**APPLICATION FOR PERMISSION UNDER SECTION 16 TOWN PLANNING  
APPLICATION FOR PROPOSED MINOR RELAXATION OF PLOT RATIO RESTRICTION  
FOR PERMITTED FLAT WITH SHOP AND SERVICES AND SOCIAL WELFARE  
FACILITY (RESIDENTIAL CARE HOME(S) FOR THE ELDERLY) IN "RESIDENTIAL  
(GROUP A)" ZONE IN LOT NO. 3678 in D.D. 120, YUEN LONG, NEW TERRITORIES**

**Town Planning Application No. A/YL/319 – Submission of Further Information**

**Proposed Minor Relaxation of Plot Ratio Restriction for Permitted Flat with Shop and Services and Social Welfare Facility (Residential Care Home for the Elderly) Uses in “Residential (Group A)” Zone at Lot 3678 in D.D. 120, Yuen Long, New Territories (Application No. A/YL/319)**

**PROPOSED STREETScape PLAN**

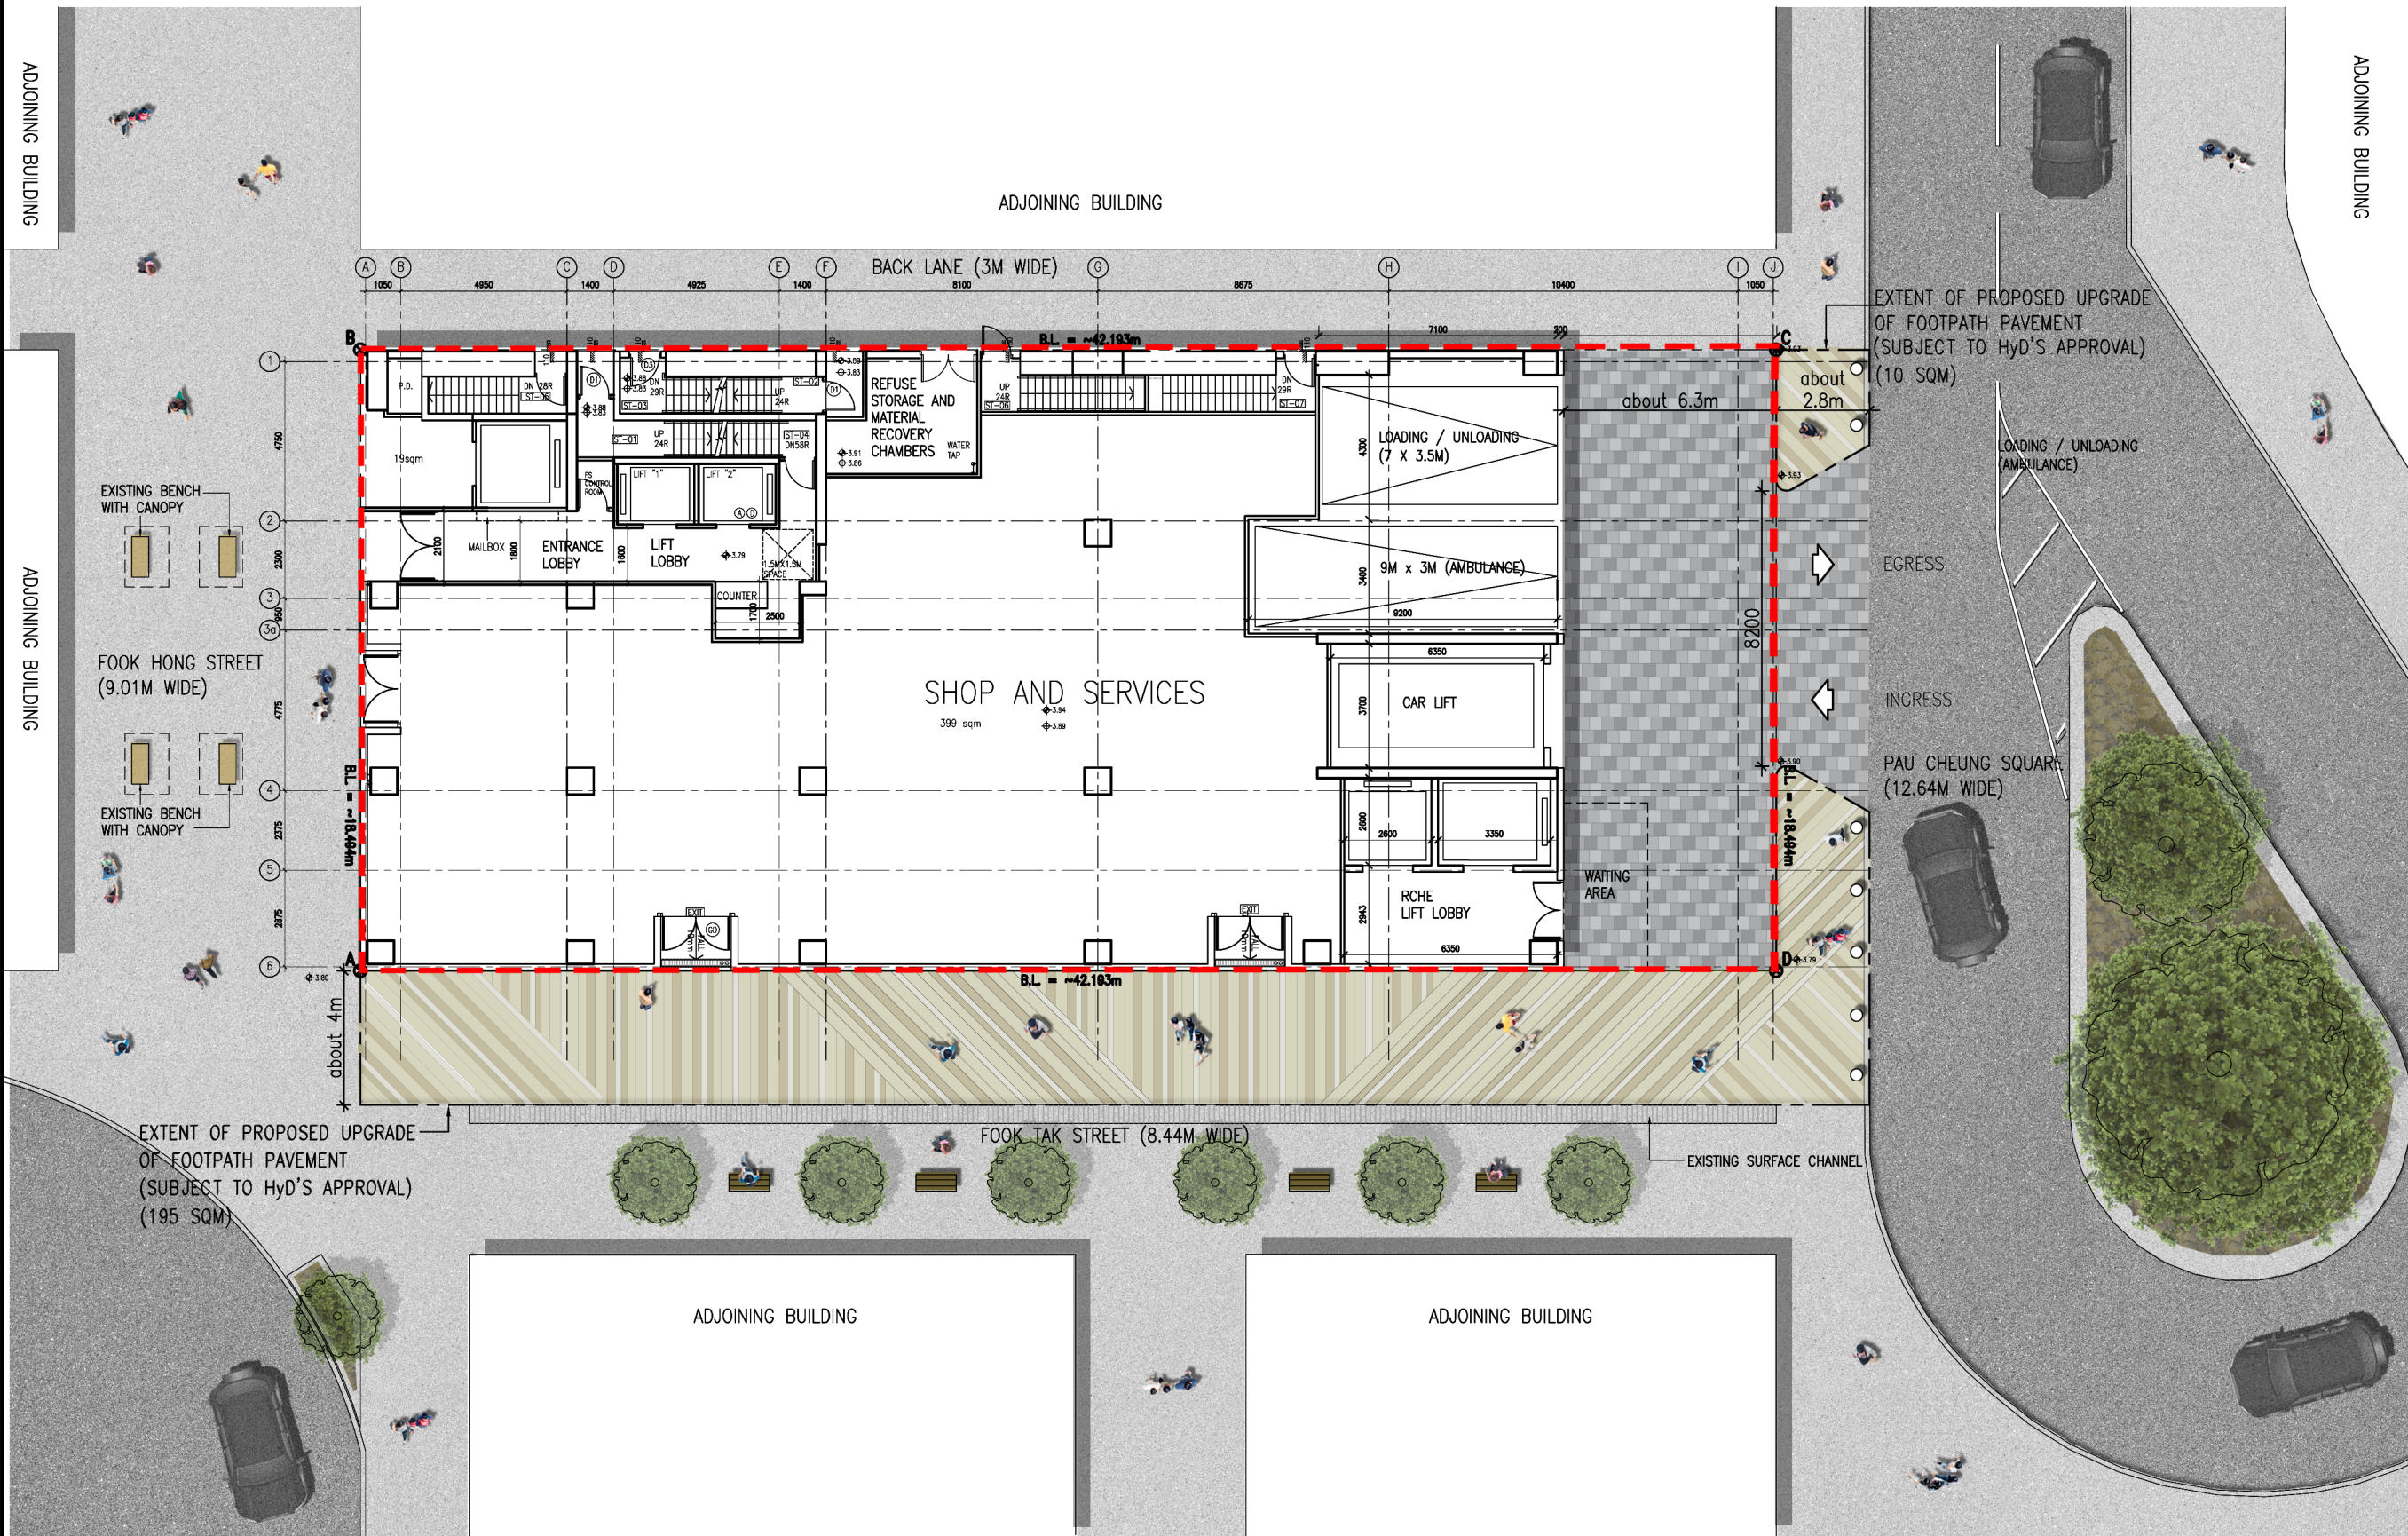
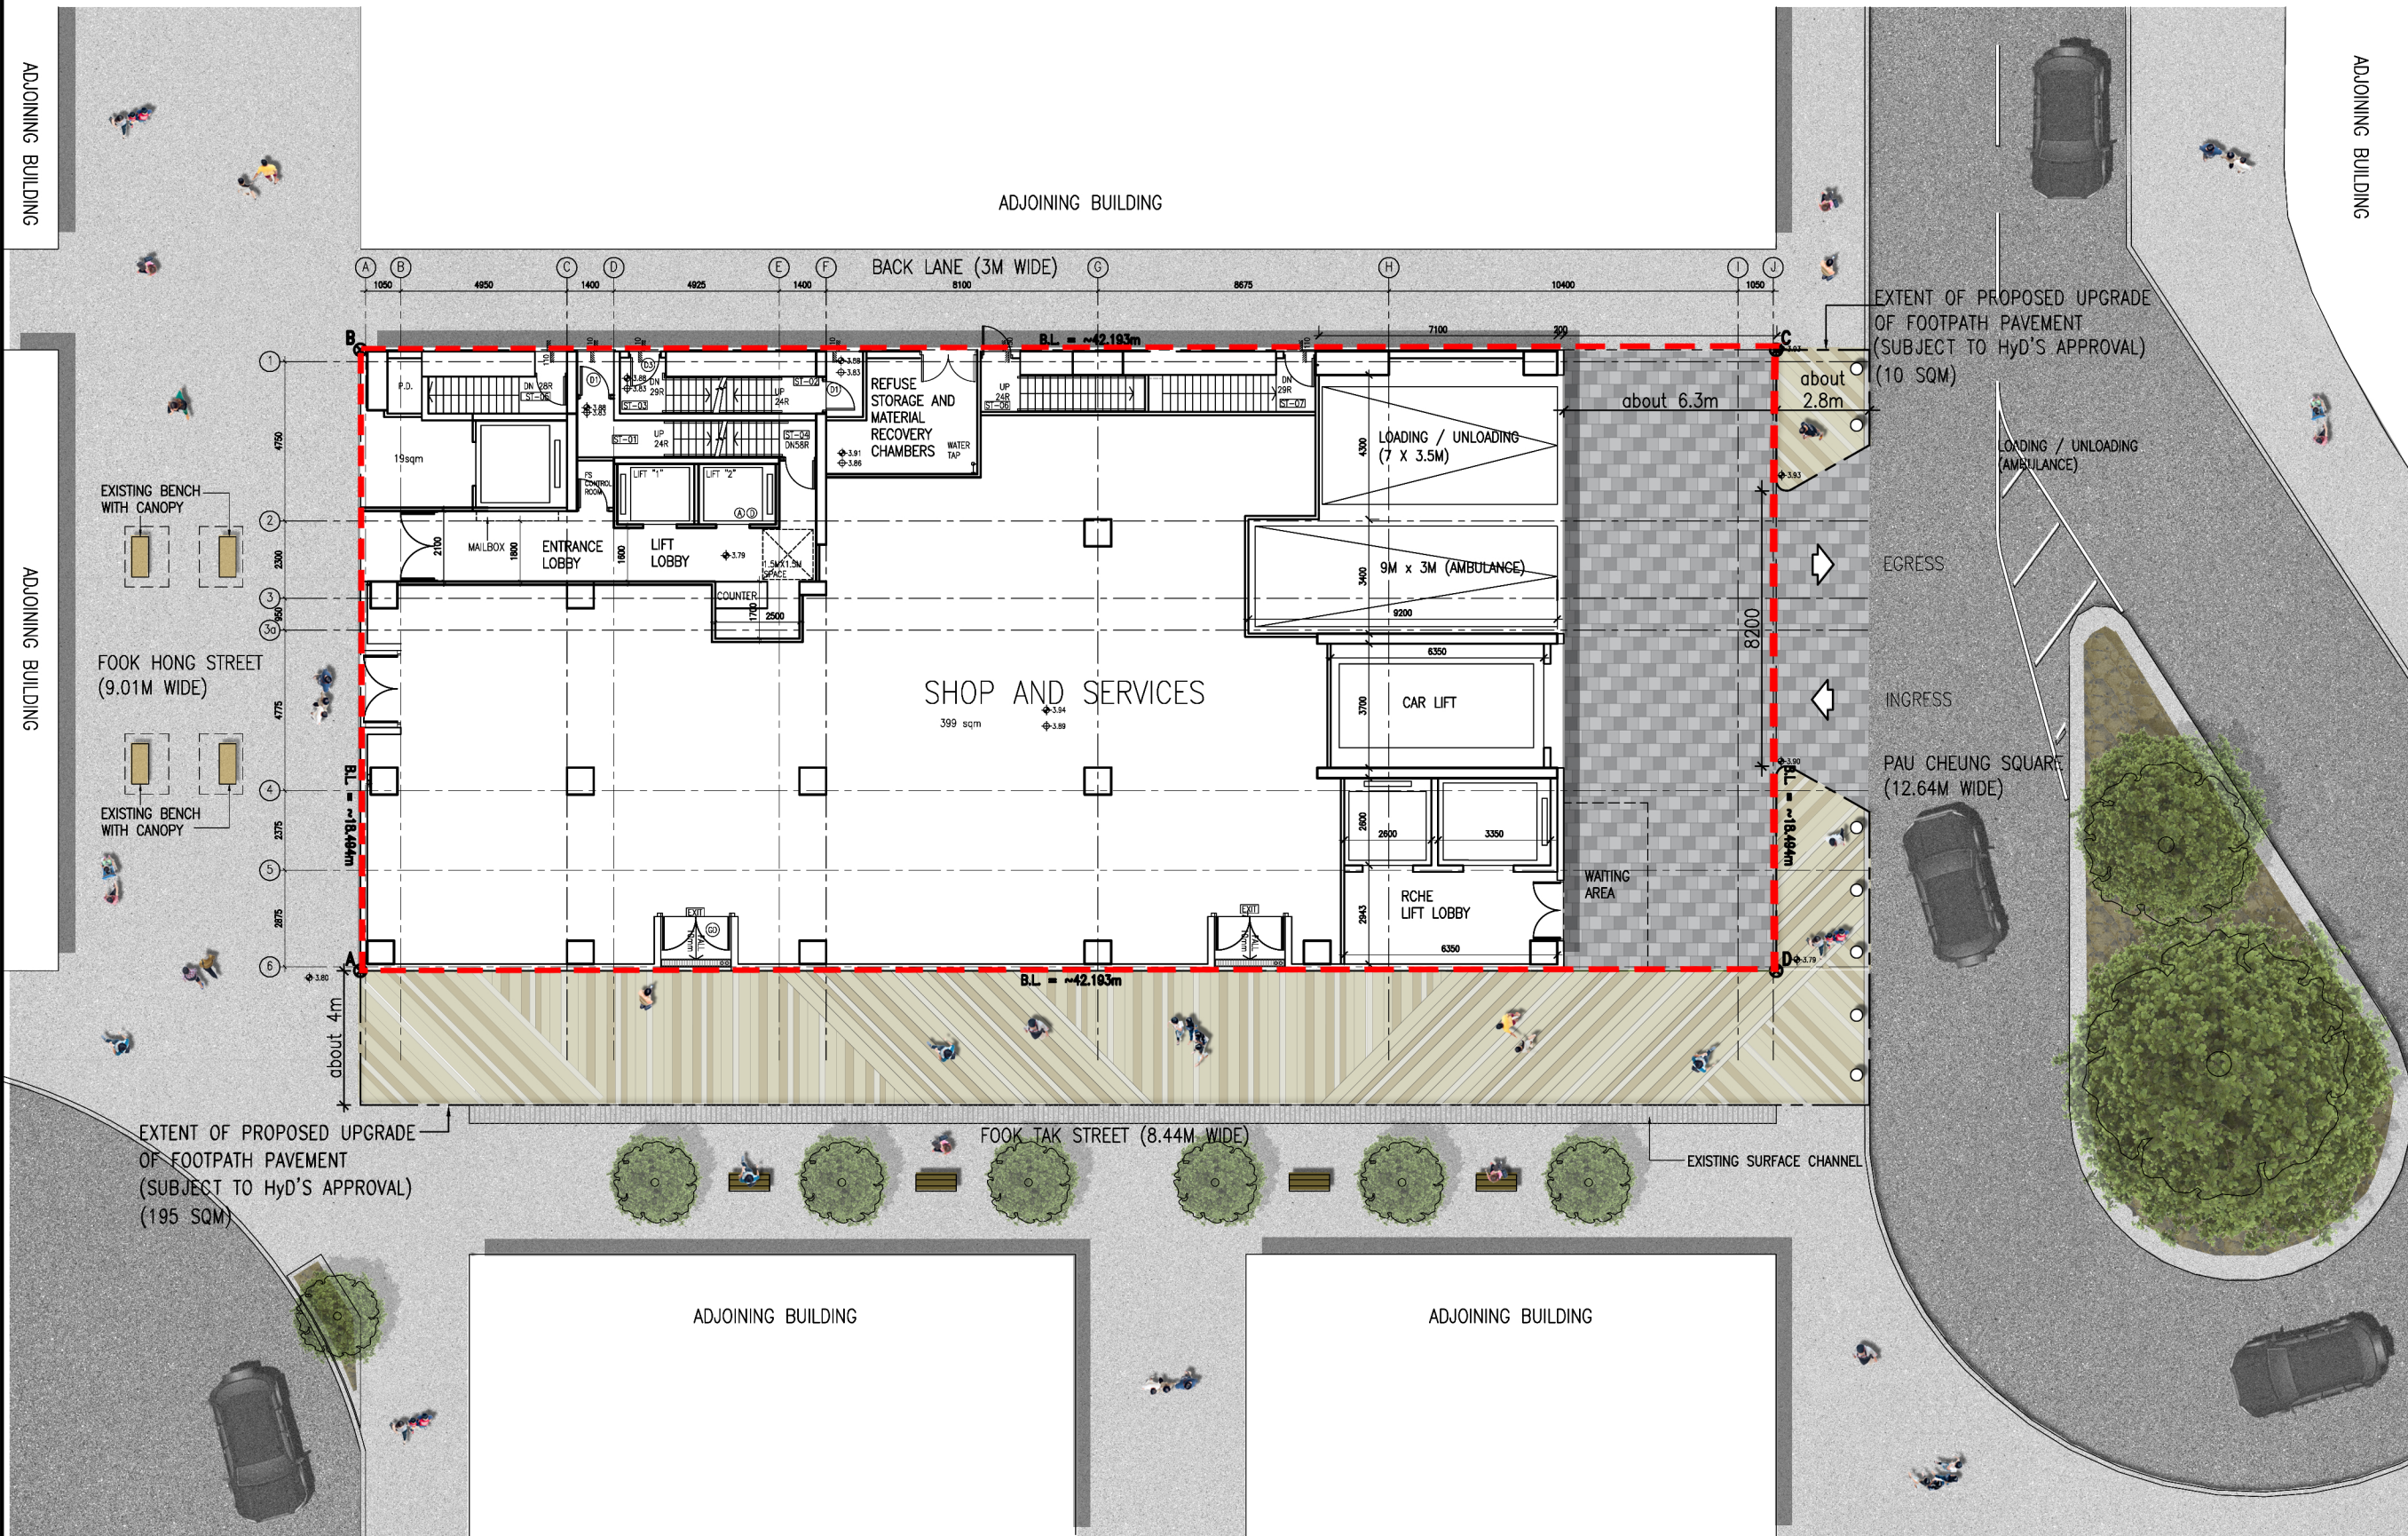
| <p>b) Noting para. 4.5(i) and the Proposed Streetscape Plan (Drawing No. GBP012), the applicant proposed streetscape enhancement works at Yuen Long Pau Cheung Square and Fook Tak Street, these proposed landscape settings and features are located outside the application boundary. Please indicate clearly the application boundary in all drawings to avoid confusion.</p>  | <p>Please find <b>Attachment 2</b> (Drawing No. GBP012) for indicating the application boundary.</p>   |
| <p>a) With respect to CTP/UD&amp;L’s comments, please check and clarify if the implementation and future maintenance parties/authorities have been sought out regarding the proposed landscape mitigation measures outside the application boundary and include this in the supplementary planning statement. Please also explain in the supplementary planning statement with details and clearly indicate the areas</p> | <p>The Applicant notes that the implementation and future maintenance of the proposed streetscape improvements will be sought from relevant government parties/authorities after the planning stage.</p> <p>For the mitigation measures of the proposed streetscape improvements, the extent of the proposed upgrade of footpath pavement will be conducted for both Yuen Long Pau Cheung Square and Fook Tak Street at the east and</p> |

| <p>with mitigation measures upon the land exchange process on the Proposed Streetscape Plan (Drawing No. GBP012).</p>   | <p>south respectively. The proposed upgrade of footpath pavement will be provided in accordance with the Highway Standard (subject to approval from the Highway Department). Furthermore, the proposed new benches will be provided further south of the paved area on Fook Tak Street to enhance comfort and convenience for the pedestrian, new bollards will be proposed along the paved area of Yuen Long Pau Cheung Square to ensure safety for the pedestrian. Please note that <b>Attachment 1</b> (Drawing No. GBP012) is an indicative streetscape design only, subject to detailed design and further liaison with relevant government parties/authorities after the planning stage.</p> |
